Amendments to the Drawings

REMARKS

Docket No. M0506-703330
Date: May 4, 2005

FIG. 1

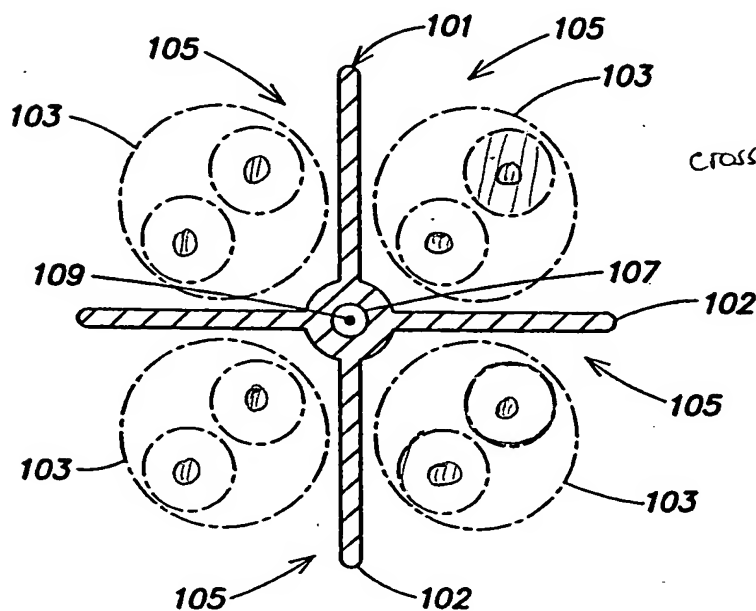
Applicant thanks the Examiner for conducting a telephone interview with Applicant's representative's assistant on May 2, 2005 to discuss the drawings. During the interview, the Examiner explained that Figures 1, 3, 4, 9B, 11 and 13 were objected because the twisted pairs of insulated conductors (and in Figs. 11 and 13, also the core and the jacket) are shown without proper cross-hatching. Applicant believes that the drawings were compliant with the twisted pairs shown in phantom lines in Figs. 1, 3, 4 and 9B because the focus of the drawings was not on the twisted pairs and the intent was to show the twisted pairs in phantom. However, Applicant's representative's assistant agreed to make the necessary changes to the drawings to overcome the Examiner's objection.

The Examiner has objected to Figures 1, 3, 4, 9B, 11 and 13 as lacking proper cross-hatching. Applicant has amended the drawings to include proper cross-hatching as requested by the Examiner. Accordingly, withdrawal of the objection to the drawings is respectfully requested. Marked-up copies of the amended figures are attached as annotated sheets 1-5.

Applicant has amended Figures 1, 3, 4, 9B, 11 and 13 to overcome the Examiner's objection to the drawings. The amendments are shown in red on Annotated Sheets 1-5 attached hereto. The amended Figures are attached as Replacement Drawing Sheets 1-5. Entry and approval of these replacement figures is respectfully requested.
